UNITED STATES PATENT AND TRADEMARK OFFICE

Office Action Summary

10/761,135

DETAILED ACTION

Handle in the first position for a right
hand assembly

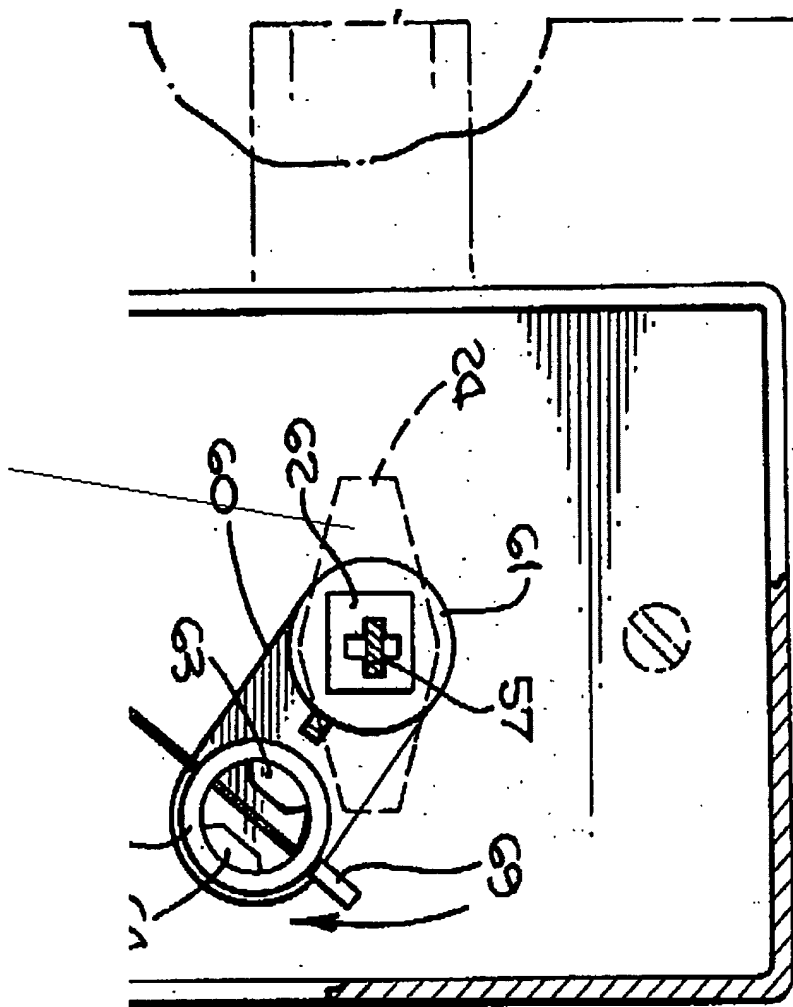
Second, the applicant is invited to look at attachment #1. Attachment #1 is a view of the assembly at a right hand side in the first position, not extended. In this view, the handle 24 is in a horizontal position.

Attachment #2 is a view of the assembly at a left hand side in the second position, extended. In this view, the handle 24 is in a horizontal position, making the first position of the handle in a vertical position.

But, since the member 57 can be placed in the horizontal part of the cross-slot or in the vertical part of the cross-slot, the handle 24 is capable of being placed in the

same position for either position of the assembly. Therefore, the rejection is maintained.
